Appendix A

Aboriginal consultation documentation

Aboriginal Consultation Log	Gunlake Quarry Project		
Stage 1 - Advisory Requests Sent			
Organisation	Contact type	Date Sent	Comment
Office of Environment and Heritage Regional Operations Group (South Branch)	Letter	2-Apr-15	Response 13.04.2015
the Registrar, Aboriginal Land Rights Act 1983	Letter	2-Apr-15	Response 13.04.2015
National Native Title Tribunal	Letter	2-Apr-15	Response 09.04.2015
Native Title Services Corporation (NTSCORP)	Letter	2-Apr-15	Response 09.04.2015 (their letter is incorrectly dated)
Southern Rivers Catchment Management Authority (Local Land Services)	Letter	2-Apr-15	Response 09.04.2015
Goulburn Mulwaree Council	Letter	2-Apr-15	Response 09.04.2015
Pejar Local Aboriginal Land Council	Letter	2-Apr-15	Response 20.04.2015
Goulburn Post Ad Run 08/04/2015	Email	2-Apr-15	Ad paid to run on 08.04.2015
Aboriginal Group Notifications Sent			
Organisation	Contact type	Date	Comments
Pejar LALC	email	20-Apr-15

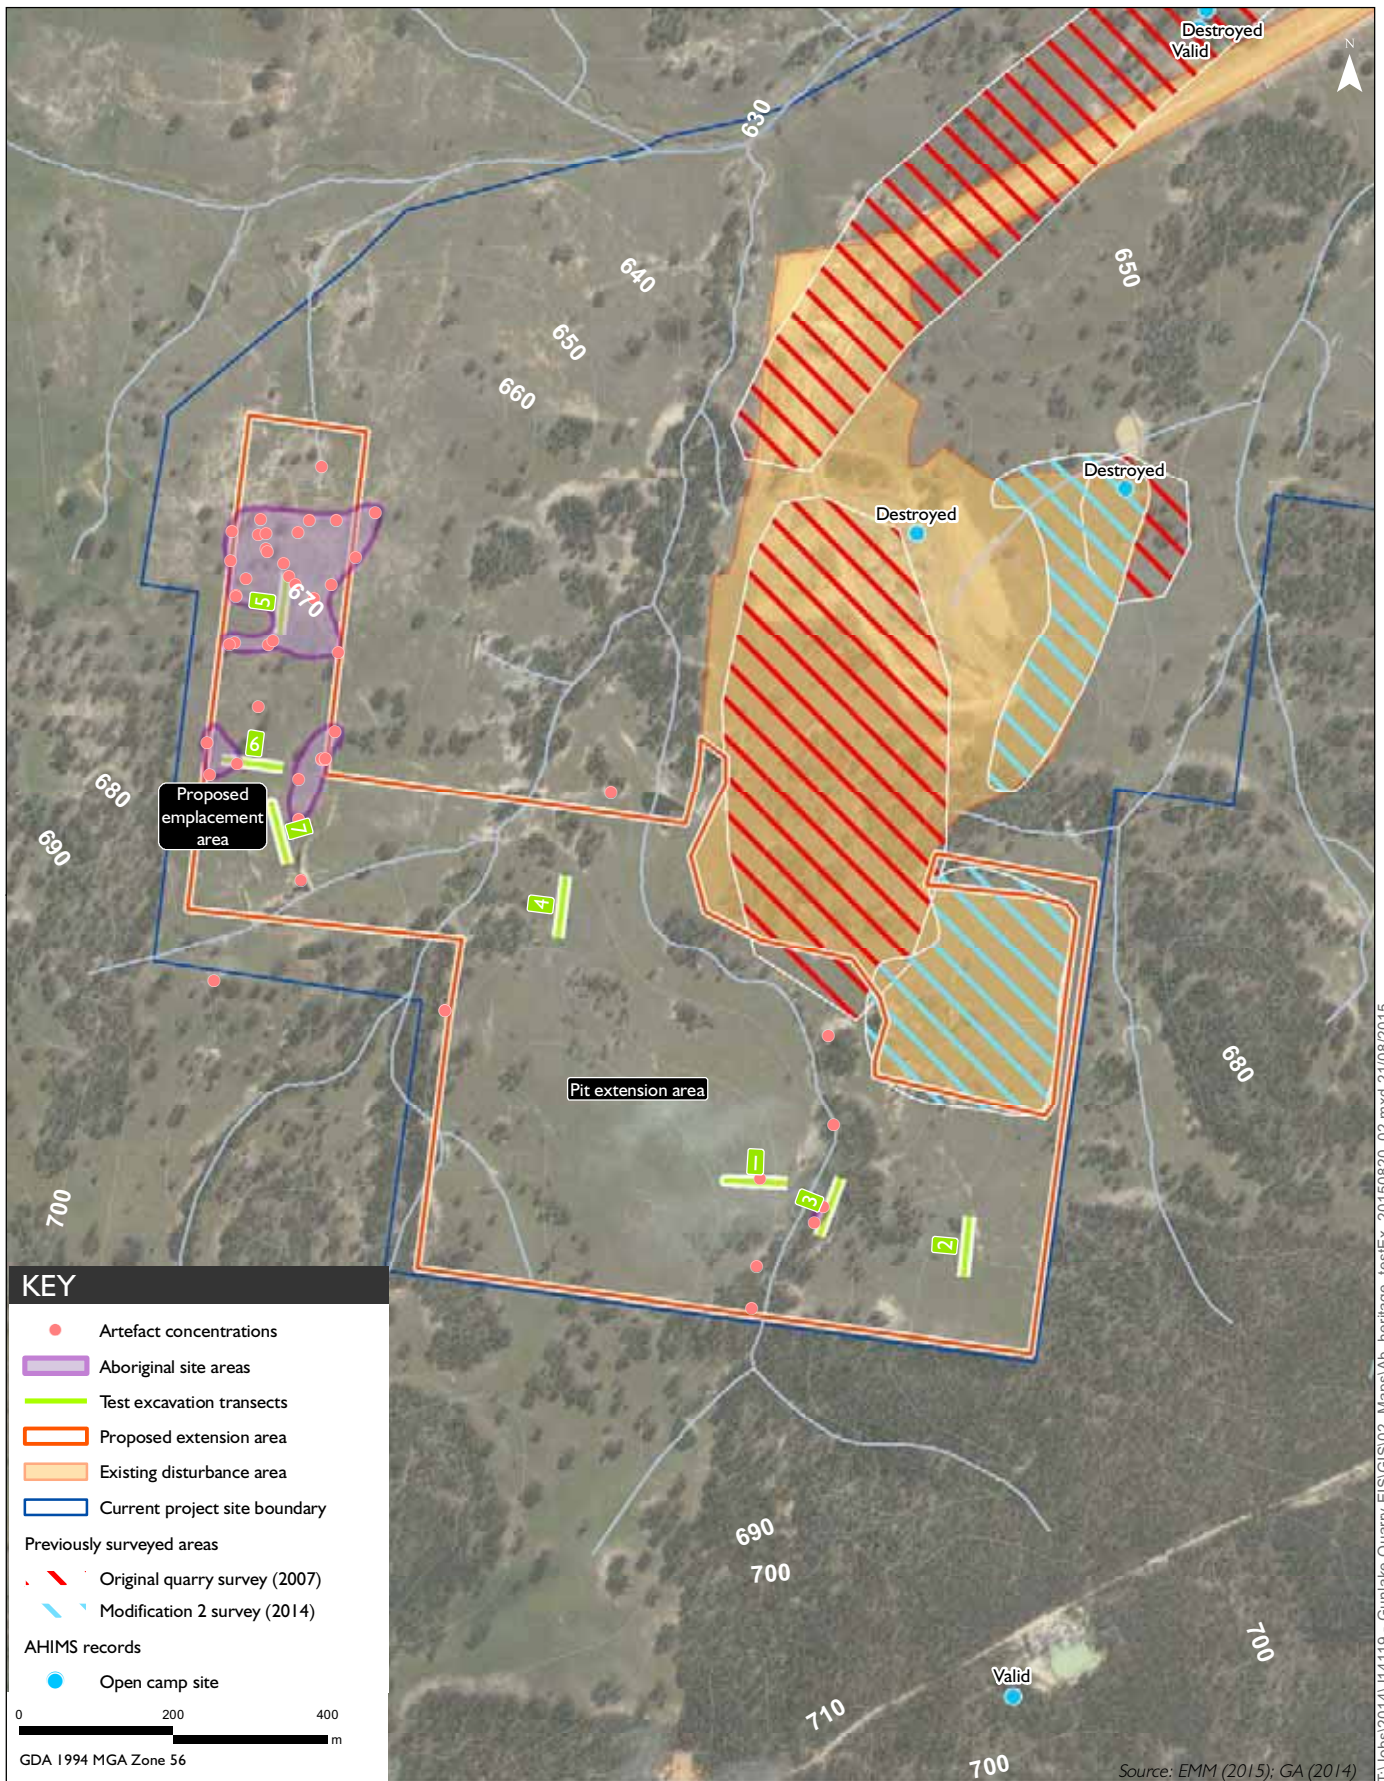
Comment (Peter Falk Consultancy)	Response (EMM)
<p><i>As the area 5 has the largest surface area scatter (300+ artefacts) and it is known that artefacts on the surface are approximately 10% of subsurface deposit. This area will have to be excavated using method of first excavating 50 x 50cm holes and expanding these holes by 50 x 50cm holes based on number of artefacts found per spit per hole.</i></p> <p><i>This will give you the largest possible salvage of the area and will expand your knowledge of the Aboriginal Cultural attributes in this site.</i></p>	<p>This comment, and your response provided over the phone, raised the concern that the large artefact scatter was not being adequately tested. We would like to clarify that the limited testing proposed in this area aims to firstly verify if the surface finds are indicative of a much larger subsurface deposit. If so, and if the site is determined to be of high significance, there is the potential to relocate the proposed emplacement area. Therefore, we aim to avoid further unnecessary impacts by limiting our testing in this area with the aim to conserve the area, if warranted (as you know test excavation is a controlled impact, but an impact all the same).</p> <p>The method currently involves excavation of 1 m x 1 m test pits only. Our experience in the region indicates that, because of the nature of the soils and previous land use disturbance, the use of this test pit size is suitable for the test excavation and any reduction in the size of the excavation units will not result in a noticeable variation of the results.</p> <p>Note that as per your reference to salvage, we will only be undertaking test excavation at this stage of the project.</p>

5. It would however be best to try and incorporate the Code of Practice requirements as much as possible into your strategy, where possible. This follows into section 4.3 – Excavation Method and Figure 1 where you can adequately justify that the testing of landforms without known objects follows Requirement 15b of the Code of Practice in order to confirm areas of low potential and your predictive model.
